# N6715A-02B

# S E R V I C E N O T E

## N6715A DC Power Analyzer

### Restricting the movement of the Front Panel FFC Cable

**Figure 1.** Demonstration of the correct placement of the bracket

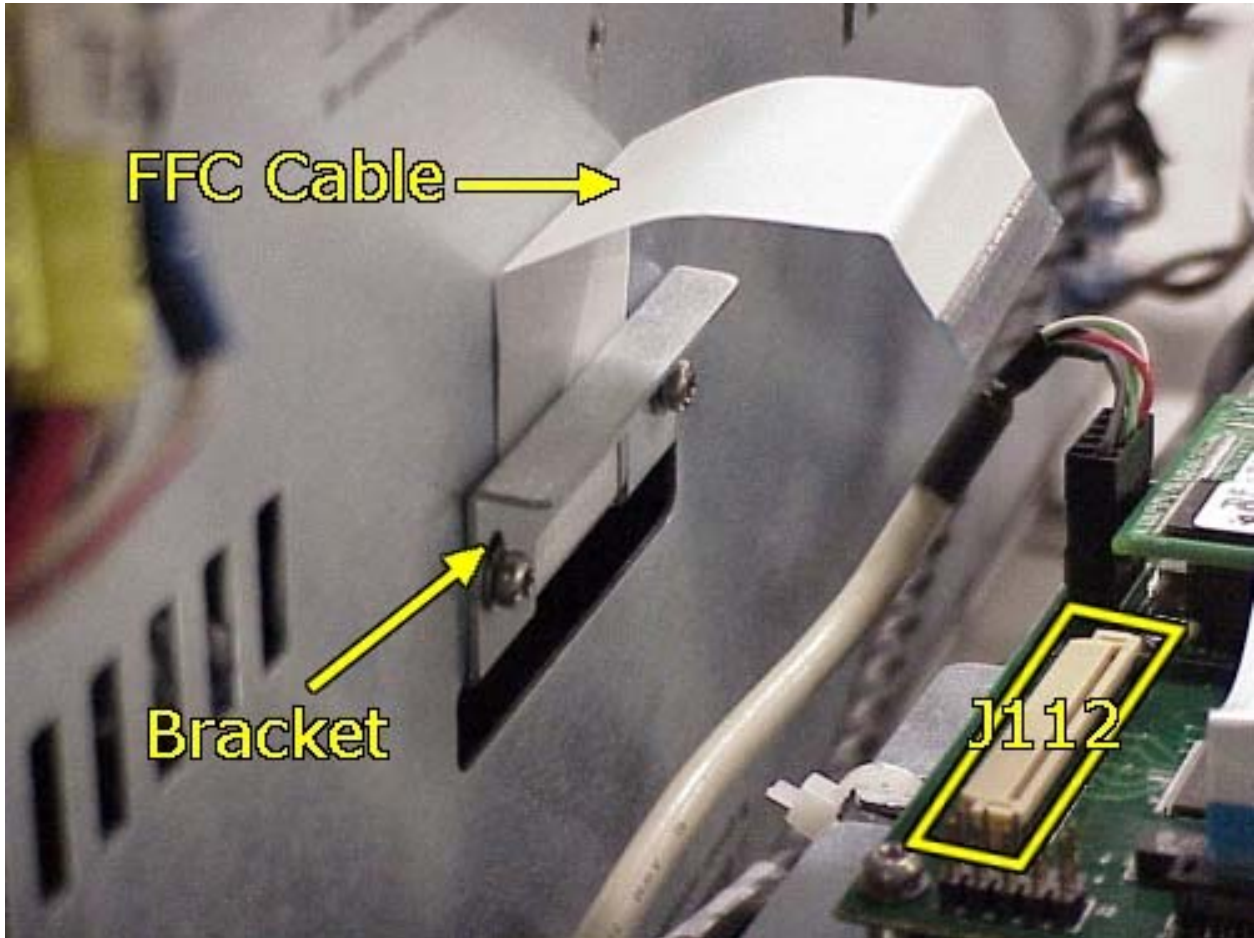
The N6715A unit is missing a bracket (P/N 5002-2882) between the front panel FFC cable (P/N 5185-8823) and the connector J112 on the P1000 board (P/N 5022-1209). This causes the connection between the FFC cable and the connector to loosen due to vibration.

If the bracket is not present as show in **Figure 1**, then follow the instructions on page 64-65 of the N6715A in order to separate the front panel from the mainframe.

To eliminate the vibration of the FFC cable it will be secured as shown in the following figures.

Make sure that the FFC Cable is properly aligned before securing the bracket with the two T-10 screws.

**Figure 2.** Close-up of the grommet that needs to be removed

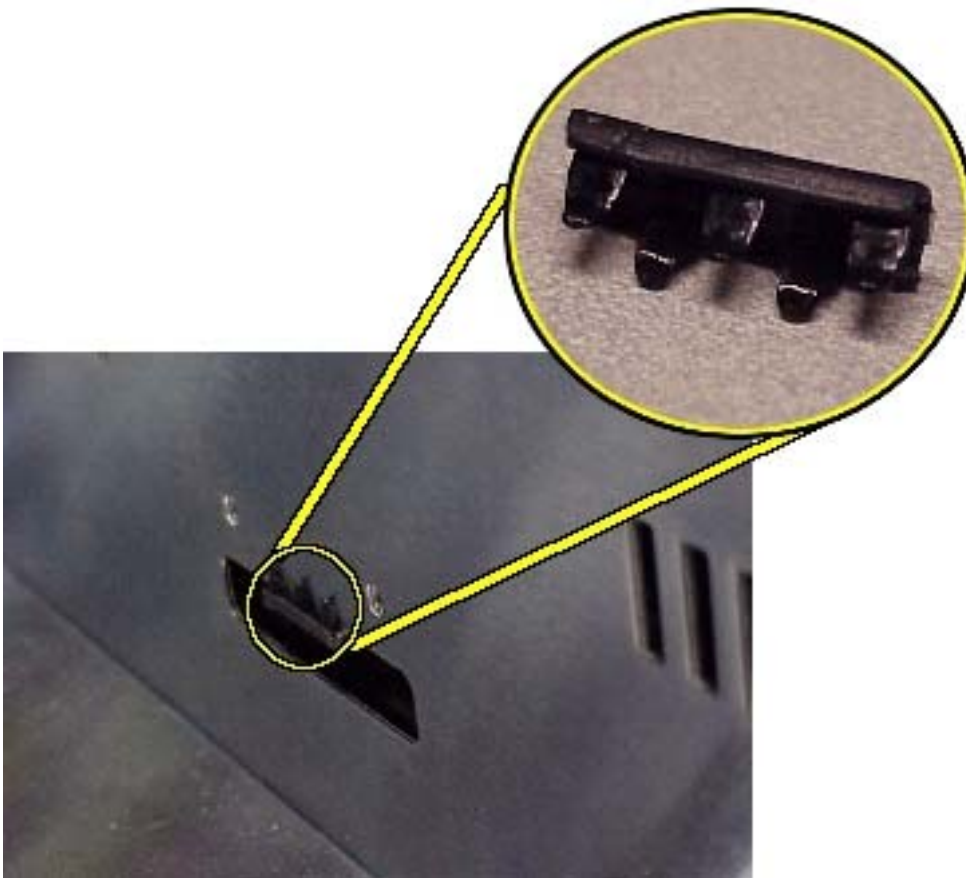
Failure to remove the grommet will damage the FFC cable when installing the bracket

Remove and discard the grommet in **Figure 2** if it is present.
